## AMENDMENTS TO THE DRAWINGS

Dong-Ho LEE  
 STACK PACKAGE MADE OF CHIP SCALE PACKAGES  
 Attorney Docket No. 9903-074/Application No. 10/750,979

Annotated Sheet Showing Changes

**FIG. 4**

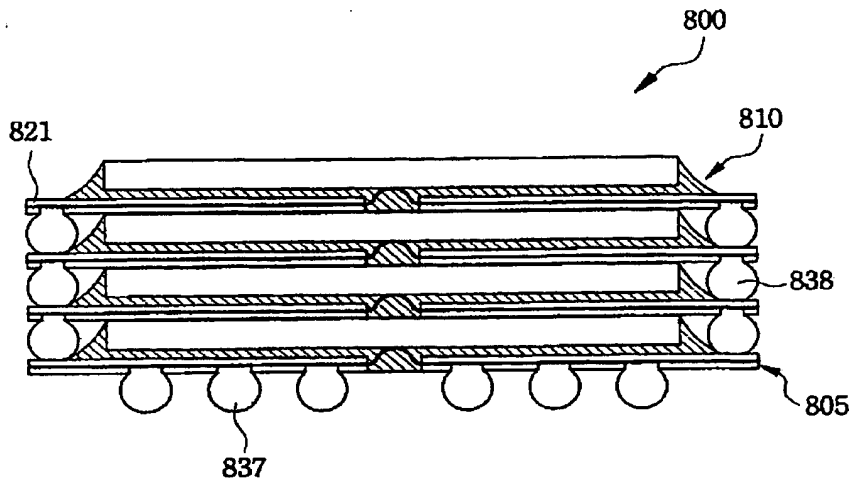
FIG. 4 is amended to correctly connect reference number 111 to the lower semiconductor chip. An annotated sheet showing changes and replacement sheet are enclosed in the Appendix following page 10 of this paper.

The drawings are objected to because in FIG. 4 the character '111' should be showing the IC and not the substrate.

FIG. 4 has been amended to correctly connect the reference character '111' to the IC and not the substrate. The amended replacement sheet is enclosed in the Appendix following page 11 of this paper.
